## **IMPORTANT SAFETY RECALL 20V-103**

# SAFETY NOTICE

# SN681A

**SUBJECT:** Leveling Sensor Installation

**Figure 1 – Level Sensor Location on End Mount Machine**

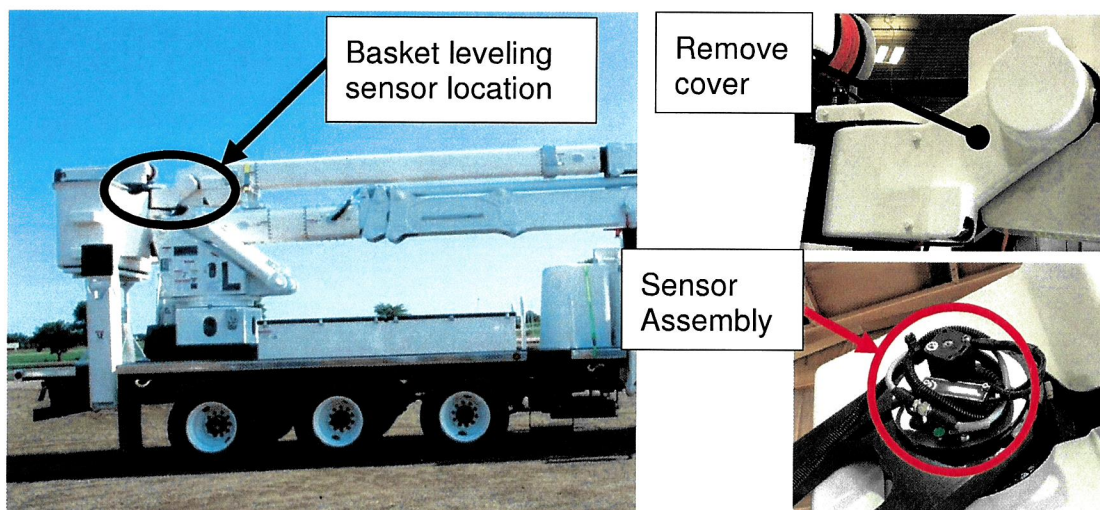
On Terex TM aerial devices, manufactured from February 2011 through April 2020, the basket level limit sensors at the boom tip may have been assembled in the incorrect orientation. The limit sensors prevent the platform from going more than 15 degrees from level if the electrical system malfunctions or there is damage to components. The incorrect mounting of the level sensors may cause an out of level basket to continue moving more than 15 degrees out of level. **If the leveling system malfunctions it may cause the occupants to fall from the platform.**

**Figure 4B**

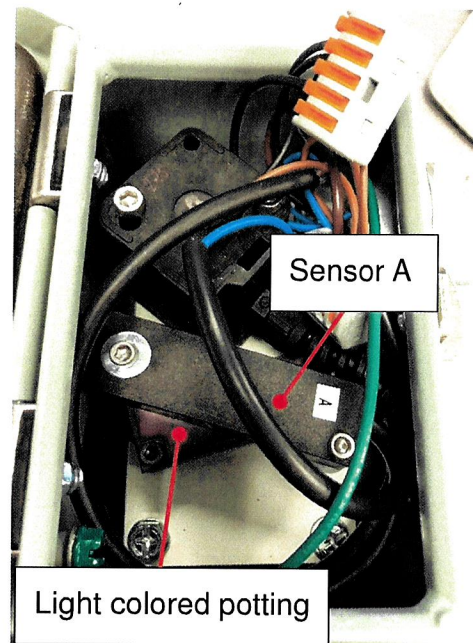
This bulletin does **NOT** apply if the light colored potting only visible on bottom sensor and sensor labeled A on top
